# TECHNICAL SERVICE BULLETIN

<b>ISSUE DATE:</b>	05/04/2023
<b>SERVICE BULLETIN SUBJECT:</b>	RR and ZX5 CAN Gateway Update
<b>VINs or MODELS AFFECTED:</b>	Service Specified Buses
<b>COMPLETE BY:</b>	Next Service Opportunity
<b>SERVICE BULLETIN #:</b>	SC-23-062
<b>LABOR OPERATION CODE:</b>	EE50Z

## RR and ZX5 CAN Gateway Update

Figure 1: CAN Gateway location

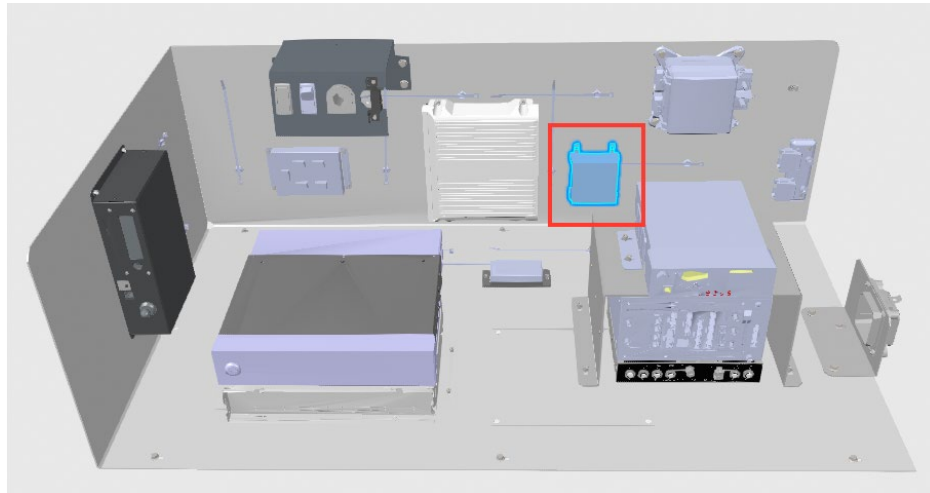
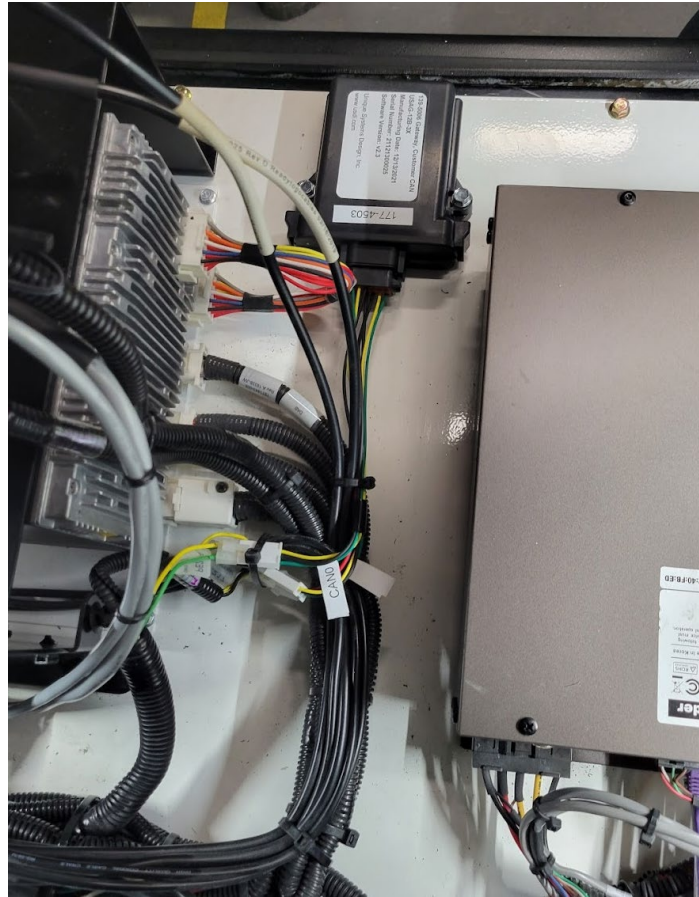
1. Use the Proterra approved Lockout/Tagout procedure to make the bus safe for work.
2. Locate old CAN Gateway (PN: 043330) on the ITS Plate.

3. Disconnect the CAN Gateway and remove from the ITS Plate.
4. Connect Harness (PN: 187-8303) to the existing CAN connections on the ITS harness that were unplugged from the CAN gateway. This will be the jumper for the new gateway connection.
5. Locate area for new CAN Gateway. This should be the same location as the old on most configurations.
6. Mount the CAN Gateway to the location via self-tapping screws (PN: 024976-004).
